Network Camera Firmware Version: V5.7.0

Release Note

(2021-11-09)

2xx3G2(D), 2xx6G2(D), 2xx7G2(D) Camera V5.7.0 Features

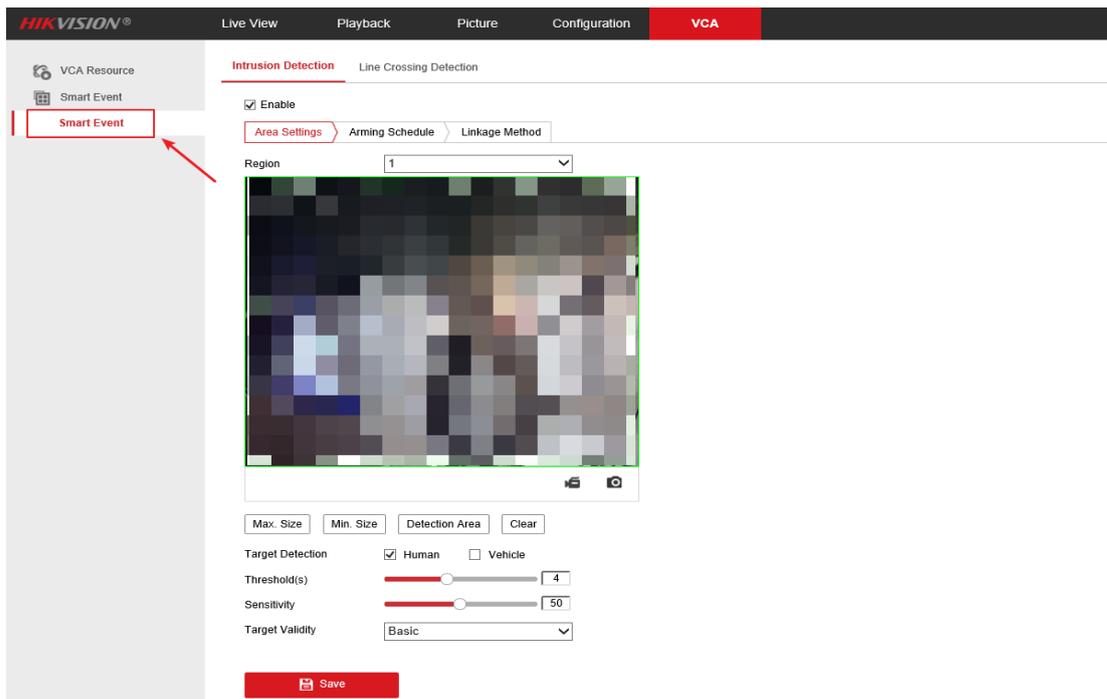
- The VCA Resource and Smart Event is changed from the Configuration to the Intelligent Warehouse interface

Before changing

After changing
